# Crook County Road & Bridge Department

## **CORRECTION TO FENCING BID**

## **ADDENDUM TO FENCING BID**

### **MOORCROFT SHOP FENCE AND SUNDANCE SHOP GATE**

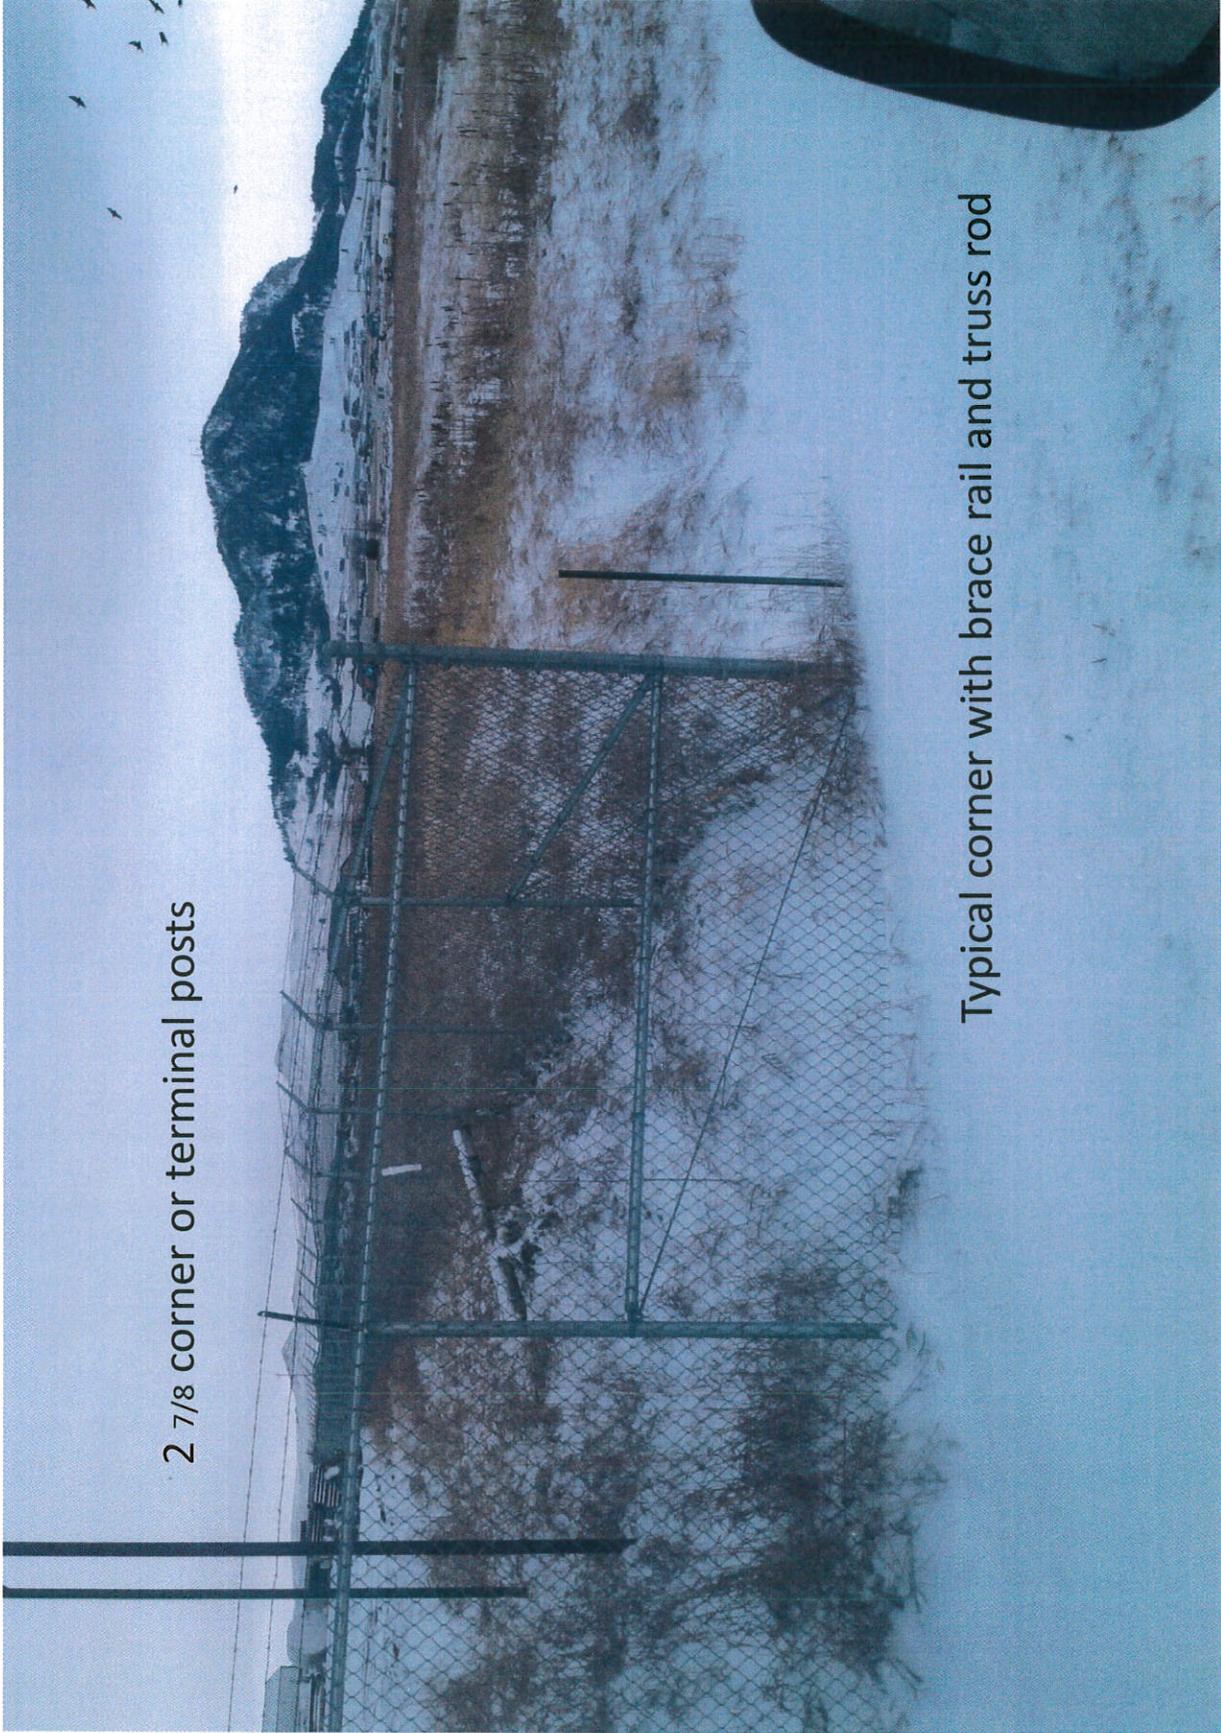
Crook County Road and Bridge has been informed of an error in the fencing bid. On photograph 2, it should read 2" diameter line posts. The top rail will be a continuous 1 5/8" rail.
